APPLICATION FOR SUBMITTAL OF POST-APPROVAL DOCUMENT

School District/Owner: Oxnard Union High School District	DSA File Number: 56 H4
Project Name/School: Camarillo High School Alterations Project / Camarillo High School	DSA Application Number 03 120049

Added dust collector exhaust ducting connected to existing wood shop equipment. Added reduced pressure backflow preventer for sprinkler connections at dust collector. Added electrical power, transformer and panels for dust collector. Revised locations of NR/I-1 and CP/I-1, and (N) Panel 'HI'. (Reference CCD#22 for dust collector unit)

CCD 27

Sheet No.
CCD27_A01

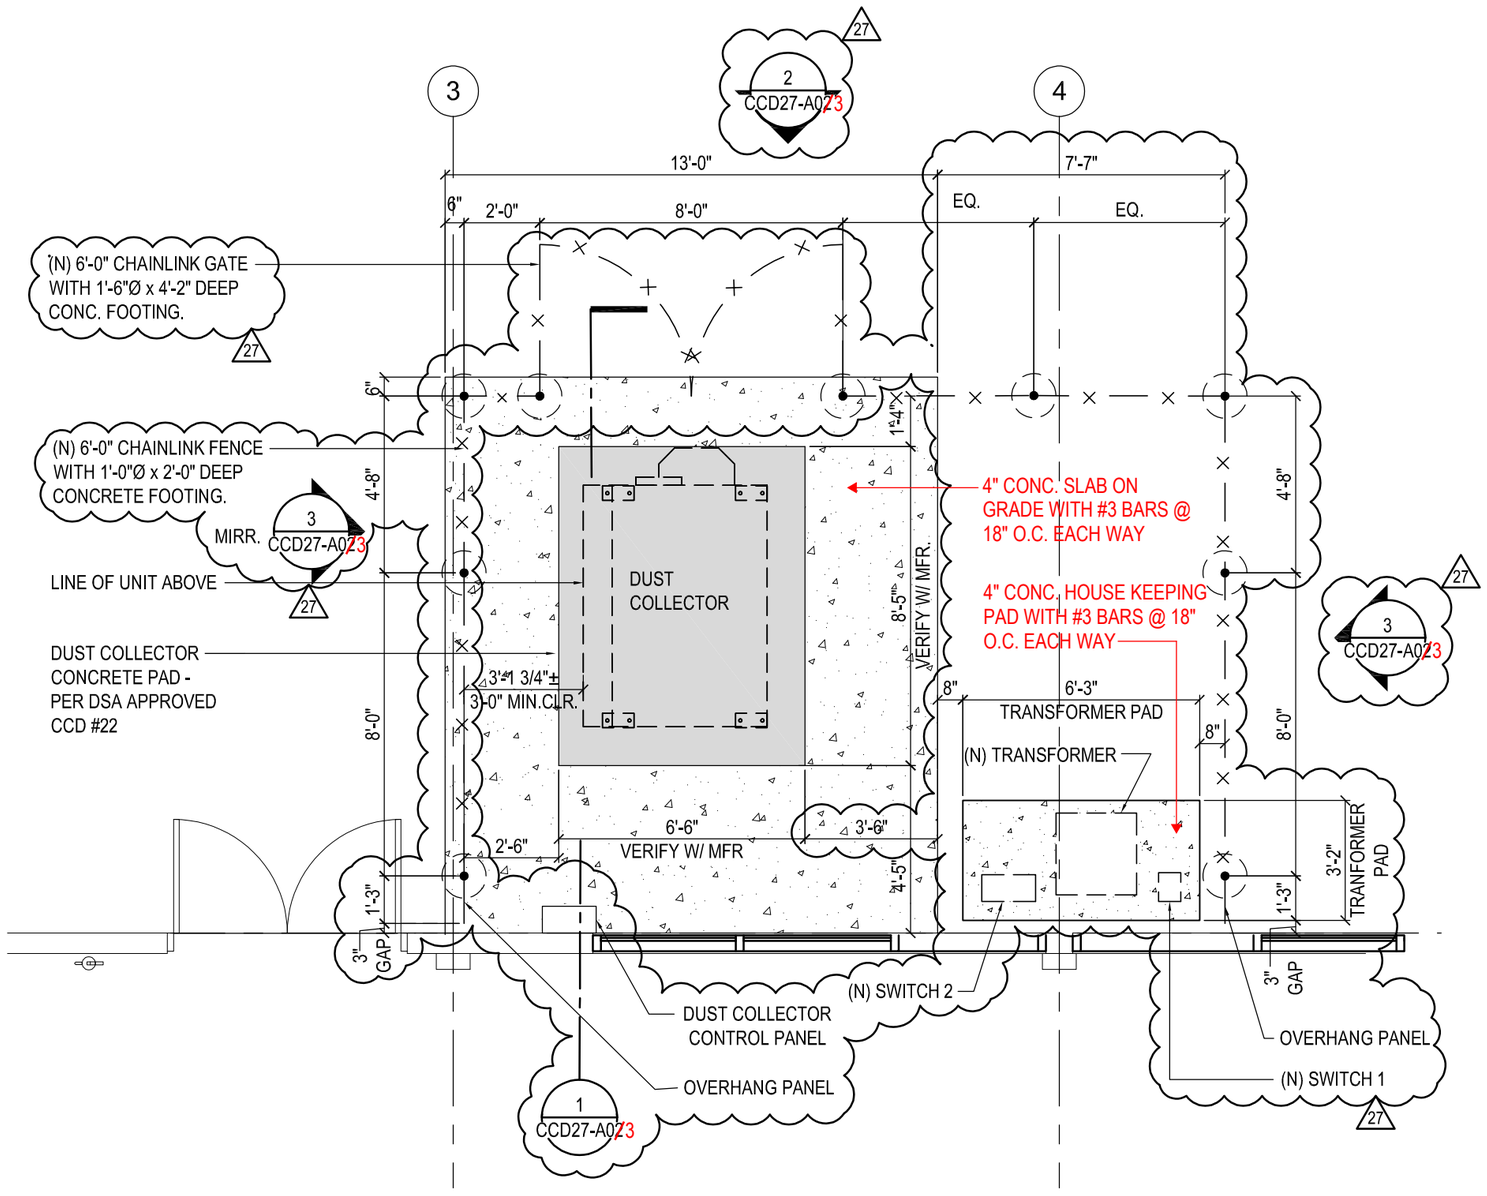
BUILDING "I"
RECONSTRUCTION FLOOR PLAN

Sheet No. MI-217D

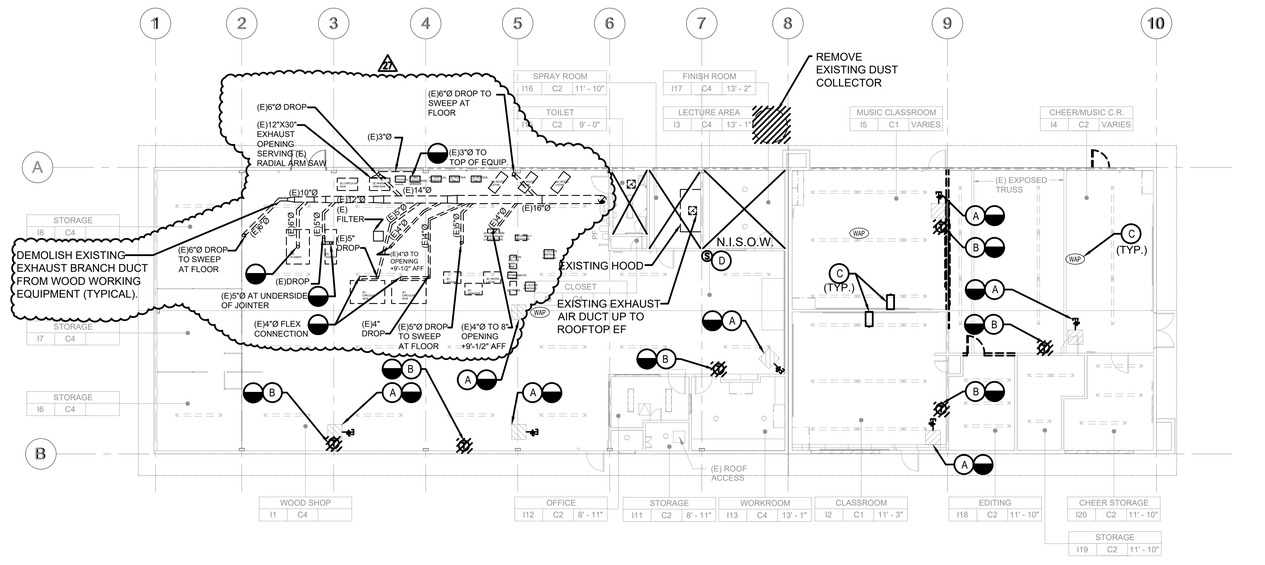
D. REMOVE EXISTING SWITCH FOR DUST COLLECTOR.

Sheet No. MI-217

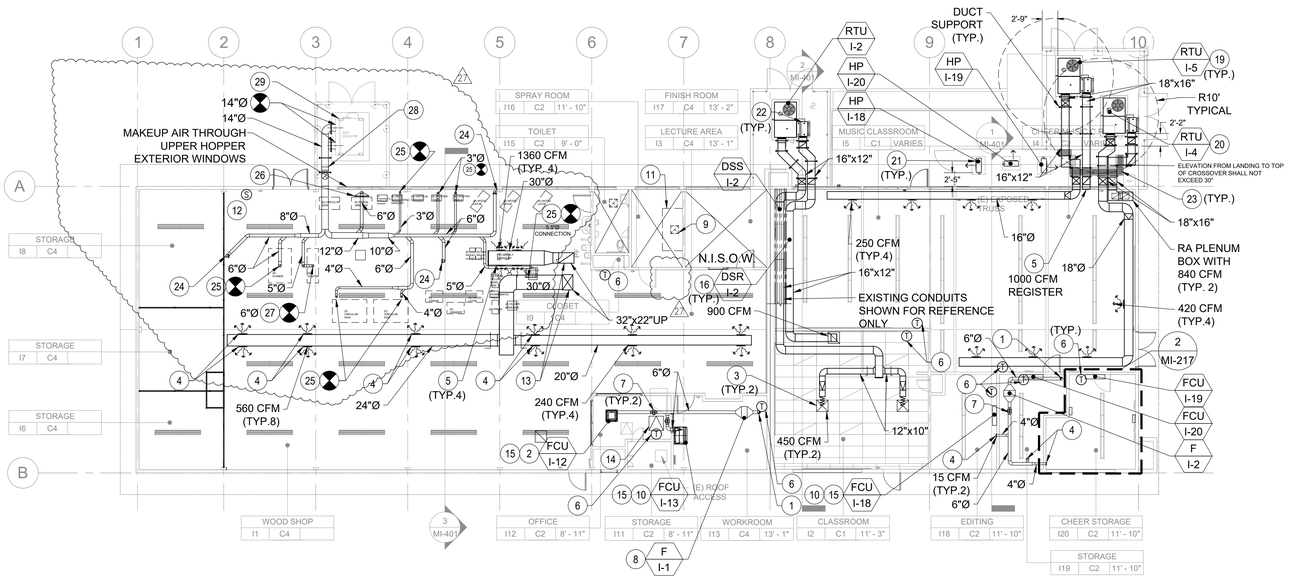
11. EXISTING HOOD SHOWN FOR REFERENCE ONLY. 27
12. PROVIDE SWITCH FOR DUST COLLECTOR.
13. NEW SA AND RA DUCT FROM THE UNIT ABOVE.
14. PROVIDE 30"x30" CEILING ACCESS PANEL.

24. FLOOR SWEEP.
25. FLEXIBLE DUCT CONNECTION TO (E) EQUIPMENT.
26. 12"X30" EXHAUST OPENING AT (E) EQUIPMENT.
27. CONNECT FLEXIBLE DUCT TO BOTTOM OF (E) EQUIPMENT.
28. 14" DIAMETER VIGIFLAP EXPLOSION ISOLATION CHECK VALVE. MECHANICAL CONTRACTOR TO CONFIGURE DUST COLLECTOR TO SHUT OFF IN THE EVENT OF AN EXPLOSION.
29. DUST COLLECTOR - 6,500 CFM AT 8" WG.

NOTES:
1. EXHAUST DUCT INSTALLER SHALL PROVIDE EXTRA COMPONENTS AND COUPLINGS FOR RETROFITS - TURN OVER TO DISTRICT AT COMPLETION OF PROJECT.
2. DUST COLLECTOR DUCTWORK SHALL BE GALVANIZED SHEET METAL.

01/08/2026:
DUST COLLECTOR EXHAUST DUCT REVISIONS PER DISTRICT REQUEST

Job No. 2840.100
Sheet No. PI-201
Date 09/08/2020

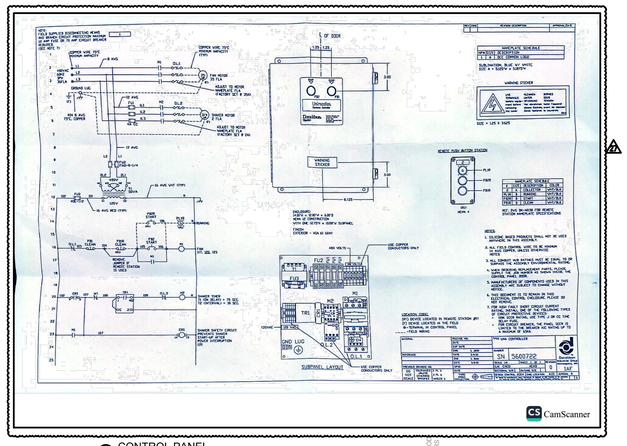
7. 1/2" CW CONNECTION WITH SHUT OFF VALVE TO DUST COLLECTOR.
8. INSTALL NEW 3/4" REDUCED PRESSURE BACKFLOW PREVENTER (RP-1) WITH ALL RELATED ACCESSORIES. RUN 3/4" ICW PIPE AND BRANCH OFF 1/2" PIPE TO DUST COLLECTOR SPRINKLER LINE INLET CONNECTION.

Sheet No. EI-201D

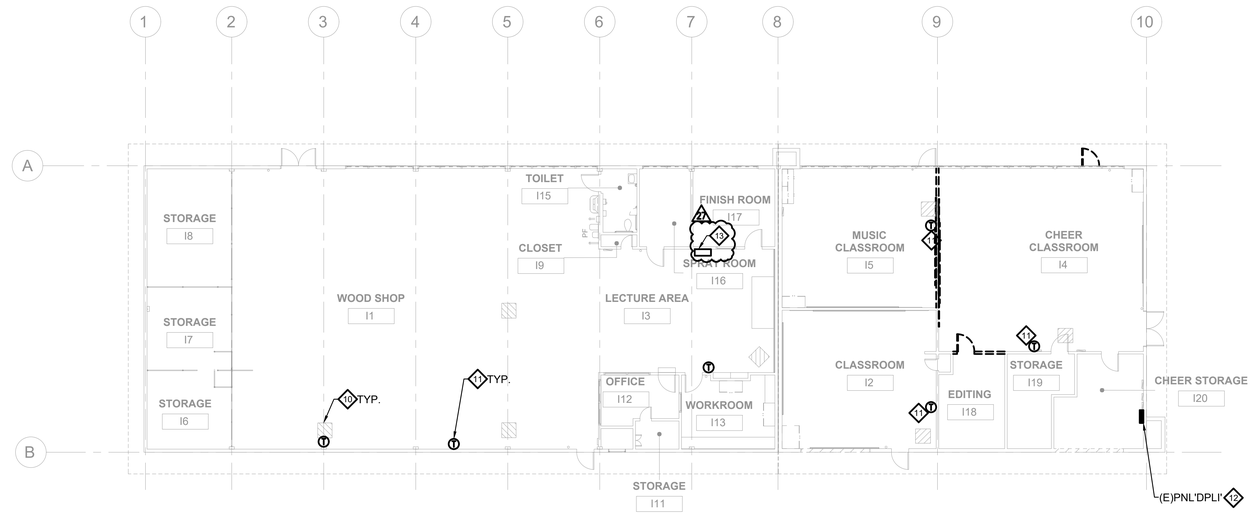
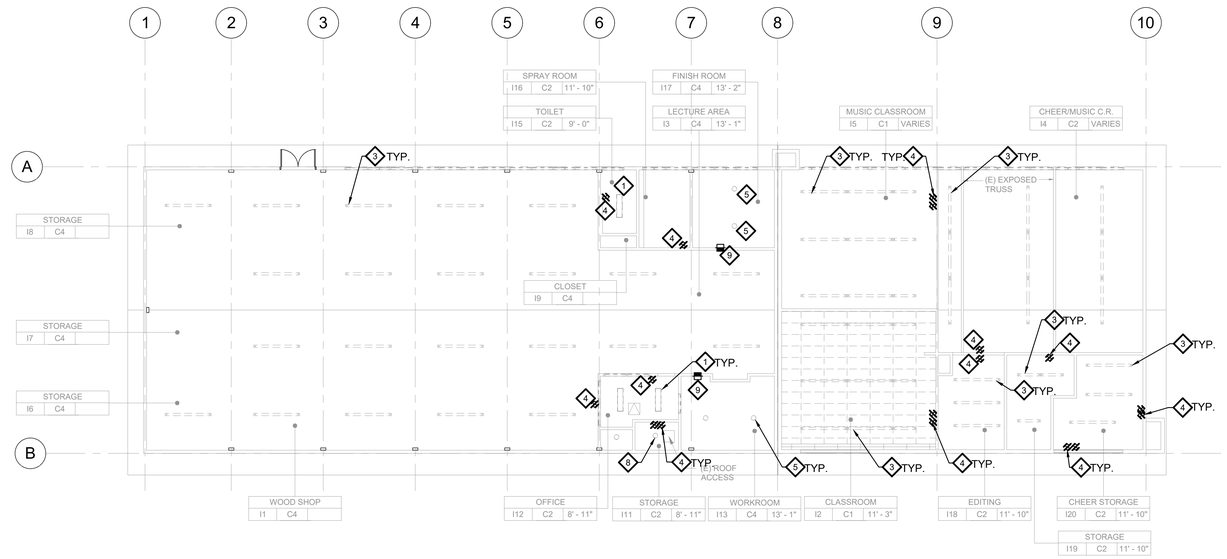
12. FIELD VERIFY THE LOCATION OF ALL (E) PANELS.
13. EXISTING DUST COLLECTOR SWITCH TO BE REMOVED, PROVIDE A NEW SWITCH.
